SoCalGas-28

**Exhibits to Prepared Sur-Reply Testimony of Tim Hower and Charlie Stinson
of MHA Petroleum Consultants (June 30, 2020)**

I.19-06-016

Ex. IV-1

Figure 2: F-4 1988 Vertilog (Left) and 2016 USIT (Right) Comparison

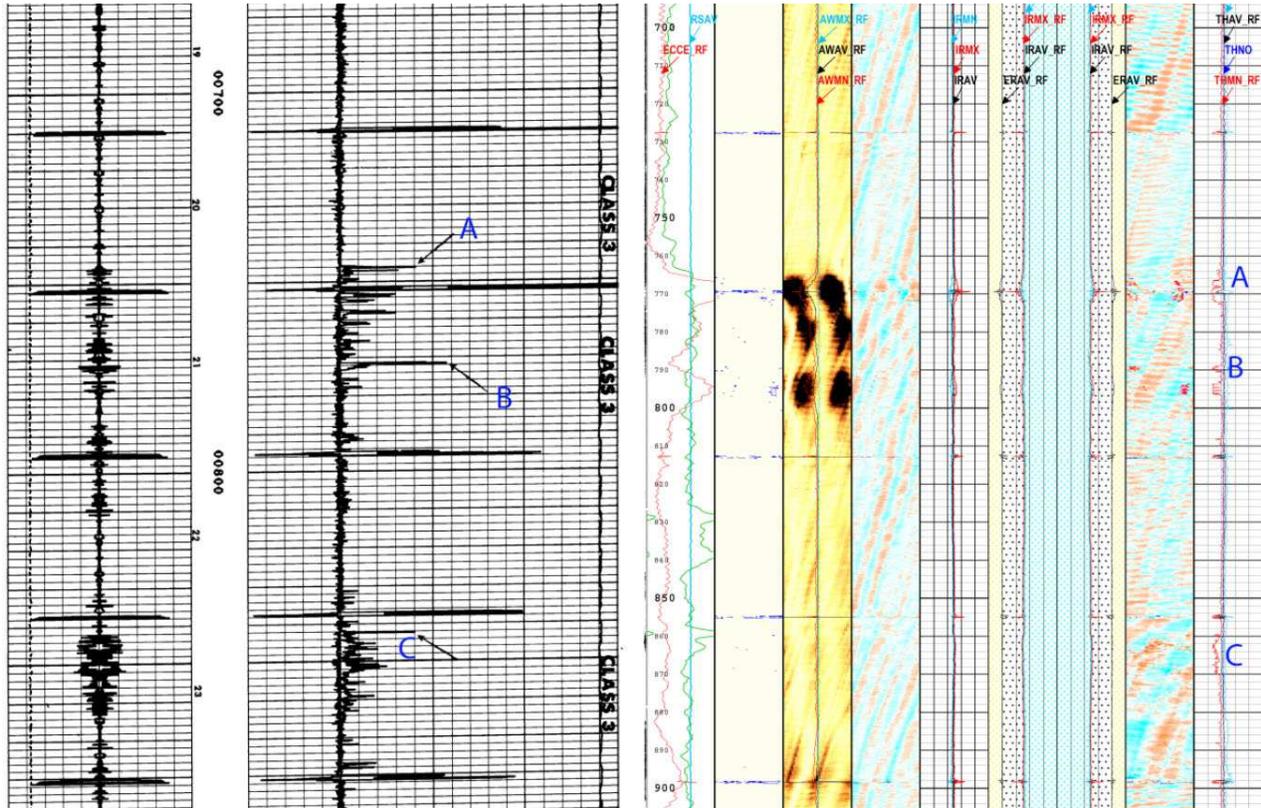
- Is there any context either in or outside of Mr. Carnahan’s testimony that Blade wishes to add in order to explain its answers? If so, please provide it and explain.

Blade performed an analysis of F-4’s 1988 Vertilog as part of the RCA [11] comparing it to the 2016 Ultrasonic Imager (USIT) log. Figure 2 shows these two logs with the Vertilog on the left and USIT on the right. To aid in interpretation from joint to joint, the logs have been adjusted so that the casing connections of each log are aligned. External metal loss is denoted by blue text at A, B, and C on the Vertilog’s Flux Leak track, and by the same letter on the USIT’s wall thickness track. At A-A, external metal loss is found just above a connection. At B-B, external metal loss is found approximately midway in the joint. At C-C, there is external metal loss below a connection. The point here is the two logs found the same defects.

There was good agreement between the logs at most depths. However, in some cases, the logs did not agree. It should not be assumed that the 2016 USIT log was the more accurate one. In Blade’s experience, MFL tools are better at detecting pitting corrosion. In general, it’s a flawed concept to compare one log tool to another and automatically claim one is more accurate than the other. Log data has to be compared to truth data (direct measurements of defects) to assess log performance. In today’s era, repeatability and reproducibility of pipeline inspection tools are verified independently in pull-through tests (e.g., Pipeline Research Council International Integrity and Inspection projects). Even today, very little data has been published in testing downhole logging tools in controlled environments. An independent comparison of casing inspection logging tools spanning decades does not exist, however, the Vertilog and other casing inspection tools could have been used as an indicator of an issue.

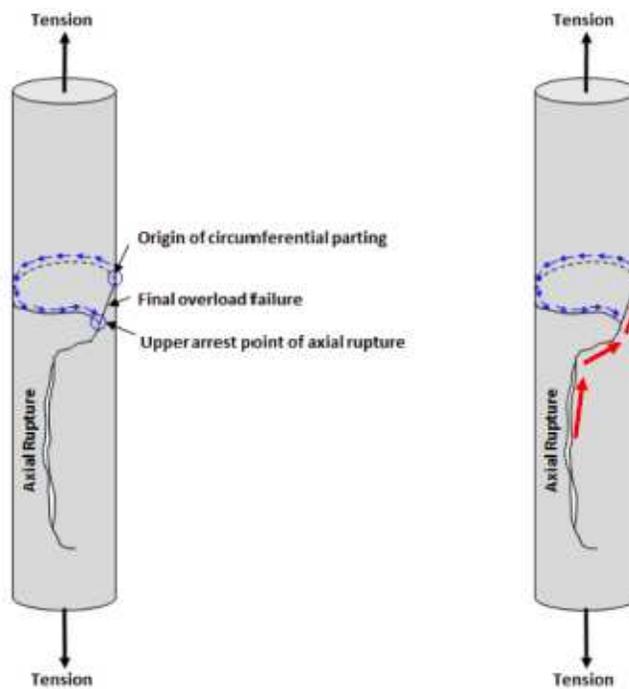
The Blade main report and various supplementary reports assert that the SS-25 7-in. casing’s vertical rupture and circumferential parting were two separate events, with the circumferential parting occurring some period of time after the initial vertical rupture, but while the well was still on injection. To the contrary, it is evident the SS-25 7-in. casing vertical rupture and circumferential parting occurred as a single event, as illustrated in Figure 12 and Figure 13, and for the reasons described below:

Mr. Carnahan’s statement does not take into consideration all of the facts provided in Blade’s Main and supplementary reports. Central to the argument are two facts. First, there are arrest turning points on both ends of the axial rupture. Second, there is no continuity of chevron marks from the axial rupture to the circumferential parting. This is further discussed in detail below.

On page 54 in Section 2.4 of Blade’s Main Report [9], it clearly states: “Visual and stereoscopic examination of the circumferential parting showed that the failure was not a continuation of the axial rupture, but rather re-initiated near the corner on one side of the parted casing. The origin site was determined based on chevron marks identified on the fracture surface. Figure 47 is a (a) laser scan and (b) image which identifies the upper arrest point, circumferential parting initiation site, and the final overload failure. Figure 48 is stitched stereo images showing the chevron marks and propagation direction of the circumferential parting. These observations indicate that the axial rupture and circumferential parting were two separate events despite their close proximity, and that they are most likely related to each other. This is discussed in more detail later within this section.” Figures 47 and 48 are extracted from the Blade Main Report.

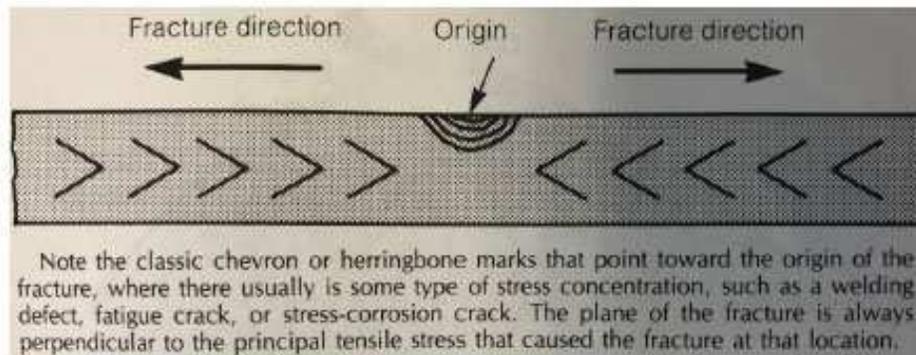
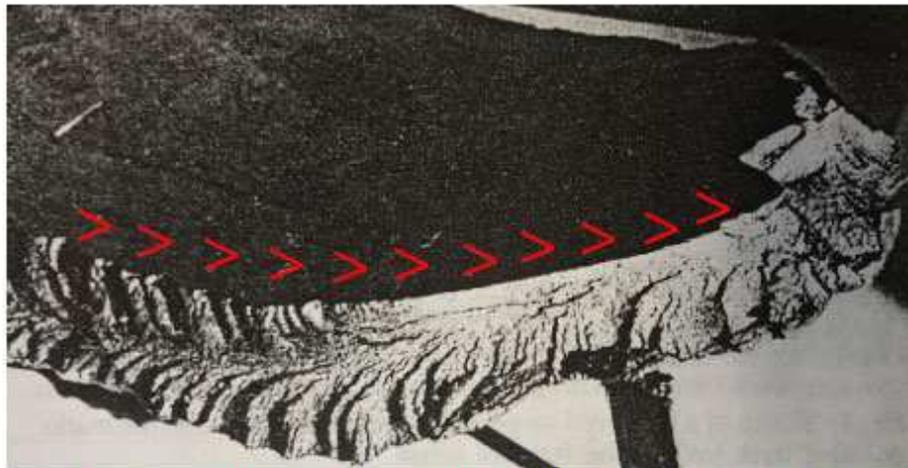
The SS-25 fracture surface exhibits clear chevron marks at a number of locations. Chevron marks denote the direction of propagation of cracks in steels – the apex of the chevron points toward the fracture origin (Figure 14). Chevron marks on the SS-25 fracture surface show clearly that the circumferential fracture is an extension of the axial fracture (Figure 15). This interpretation is consistent with remarkably similar chevron marks shown in a textbook on failure analysis (Figure 16).

Mr. Carnahan’s testimony correctly states that “the SS-25 fracture surface exhibits clear chevron marks at a number of locations. Chevron marks denote the direction of propagation of cracks in steels—the apex of the chevron points toward the fracture origin (Figure 14 provided by Mr. Carnahan in his testimony)”, however, he incorrectly states that, “chevron marks on the SS-25

fracture surface show clearly that the circumferential fracture is an extension of the axial fracture (Figure 15)”. Mr. Carnahan did not show where in the figure that he clearly saw the chevron marks extending from the axial fracture to the circumferential fracture. In contrast, as previously indicated in Blade’s response to Mr. Carnahan’s Statement 7, Blade provided macro- and micro-fractographic evidence in the Main and Supplementary Reports, see Figure 67 on page 71 of the Main Report, which shows no chevron marks present after the axial fracture was arrested and no chevron marks on the final overload rupture.

Blade disagrees with the statement because the visual and stereomicroscopic examinations performed by Blade showed that the apexes of the chevron marks are in the opposite directions around the origin. This is further clarified in Figure 68(a), page 72 of the Blade Main Report below that shows the chevron marks point back towards the origin from either side of the origin. For

Figure 68 (a), Page 72 Blade Main Report

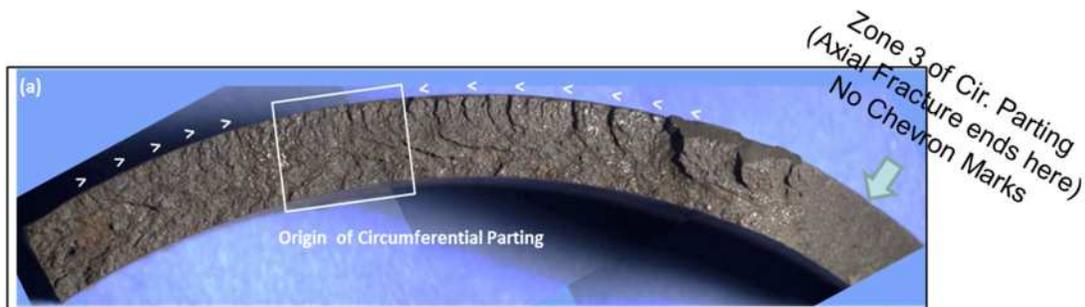
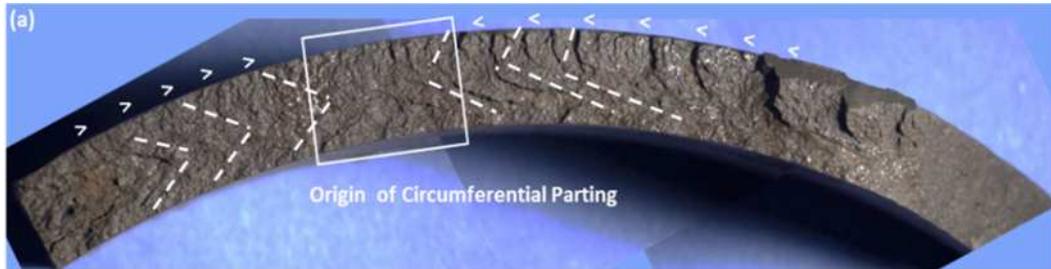
In the caption of Figure 15 below, Mr. Carnahan states “Blade misidentified the chevron marks as flowing towards the origin. Based on both my physical inspection on February 27-28, 2020, and my analysis of the image, the chevron marks travel to the right, as indicated by the red arrows at the bottom of the figure.”

Figure 15. Figure 68 from page 72 of Blade main report. Red rectangle encloses backward chevron marks drawn by Blade. Red chevron marks inserted above are consistent with chevron marks present on the fracture surface. Blade misidentifies the chevron marks as flowing towards the origin. Based on both my physical inspection on February 27-28, 2020, and my analysis of this image, the chevron marks travel to the right, as indicated by the red arrows at the bottom of the figure.

The figure below (Figure 68 (a), page 72 of Blade Main Report) shows no chevron marks on the final overload rupture. For clarity, we have annotated the upper corner on the right-hand side of the figure with the green arrow) indicating no chevron marks on the final overload failure of Zone 3 of the circumferential parting. On the circumferential fracture surface there is no extension of the axial fracture chevron marks.

clarity, white dashed lines have been added to the figure to outline the chevron marks that point back towards the origin from either side of the origin. This is inconsistent with Figure 16 of Mr. Carnahan’s testimony.

Figure 17. There are no features in either of the areas shown in Blade Figures 68b or 68c that suggest the existence of a fracture origin.

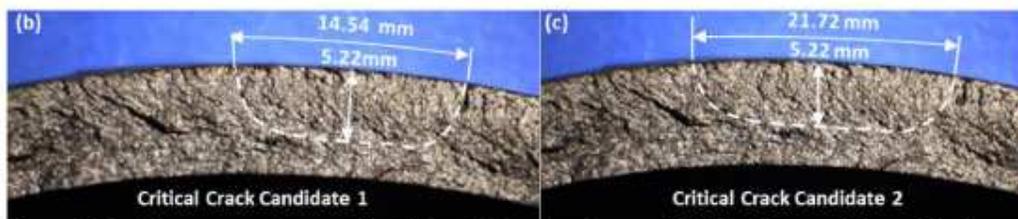
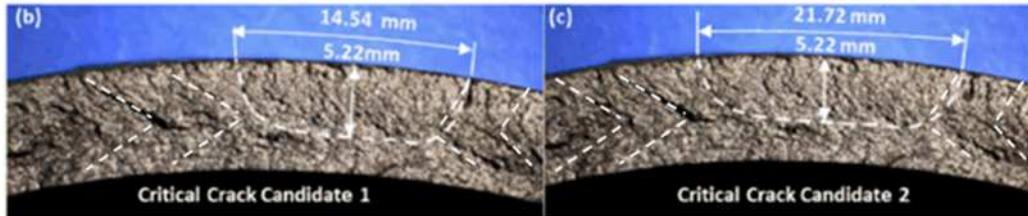
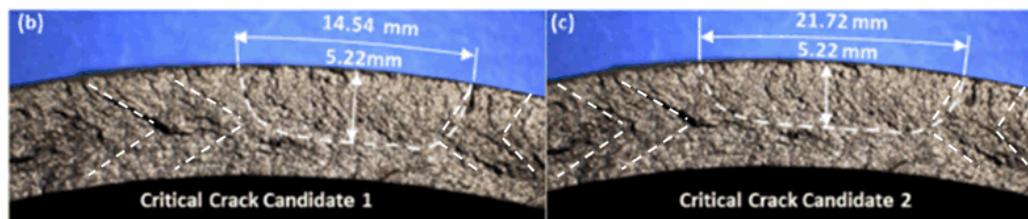
Blade’s contention that a separate fracture origin exists on the circumferential portion of the fracture is incorrect (Figure 17). Rather than a fracture origin, this area is merely a continuation of the circumferential portion of the fracture. Fracture surface markings within the hypothesized origin are the same as or similar to those outside of the origin.

An examination of the chevron marks in Figure 17 (i.e., Figure 68 in Blade’s Main Report, page 72), showed that the features inside the origin were different from chevron marks outside the origin. The examination identified an area (the origin) that was absent of chevron marks but had chevron marks on either side pointing towards it. For clarity, white dashed lines have been added to outline the chevron marks that point back towards to the origin from either side of the origin. This observation is consistent with the illustration, Figure 14, provided by Mr. Carnahan.

Blade identified the fracture origin of the circumferential parting based on the observed apexes of the chevron marks pointing at the origin, along with the presence of a pre-existing OD oxidized flaw. This was also discussed in Statements 9 and 10. Blade identified two semi elliptical areas as possible critical crack sizes (origin) for the circumferential parting based on thorough examination with the stereo microscope and SEM, one is 14.54 mm long x 5.22 mm deep and the other one 21.72 mm long with the same depth, see pages 71 and 72 of Blade's Main Report and Section 3.3.1 on page 134 of Blade's supplementary report *SS-25 Casing Failure Analysis* for details. Figure 17 provided by Mr. Carnahan in Statement 9 (i.e., Figure 68 in Blade's Main Report, page 72), with added dashed lines to outline the chevron marks), showed that the features inside the origin were different from chevron marks outside the origin. The examination identified an area (the origin) that was absent of chevron marks but had chevron marks on either side pointing at it.

Figure 19. Gas well temperature log showing cooling at the packer and perforation (Bird, 1954).

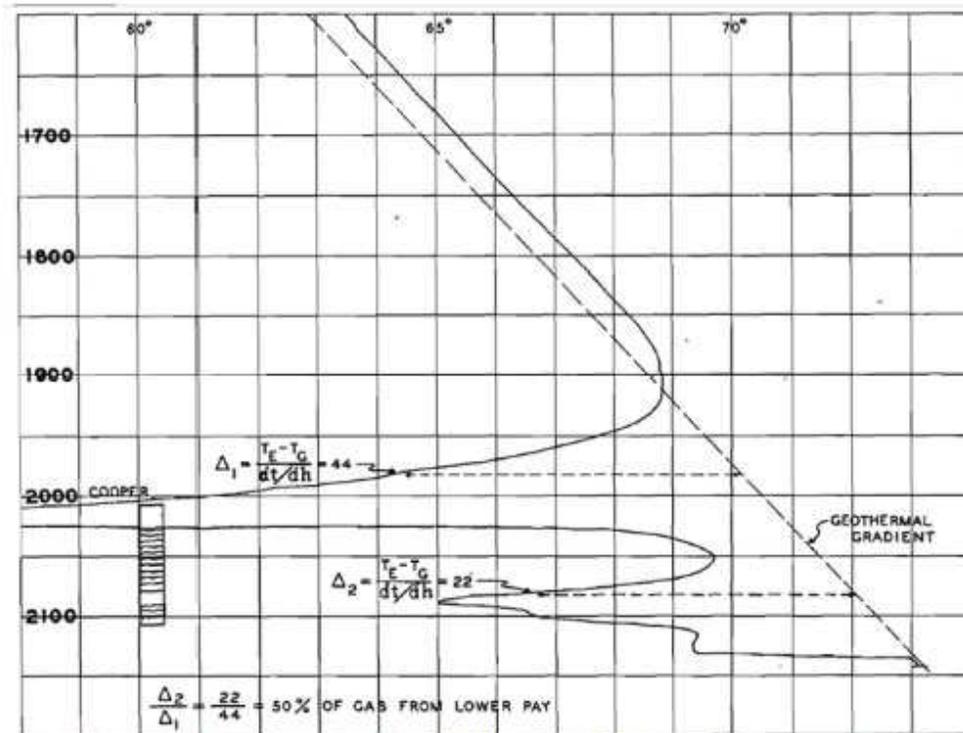
The cooling shown on the SS-25 temperature logs at this depth was not indicative of a leak. The movement of gas into or out of the storage zone always causes localized cooling; indeed, cooling behavior where a storage well meets the reservoir has been well known for many years, as can be seen in Figure 19.

All storage wells at Aliso Canyon exhibit the same or similar cooling at that depth. For example, Figure 20 shows that Fernando Fee 32A and Porter 72A both exhibit cooling at the bottom of the wells, and the same is true for SS-25A and SS-25B (Figure 21).
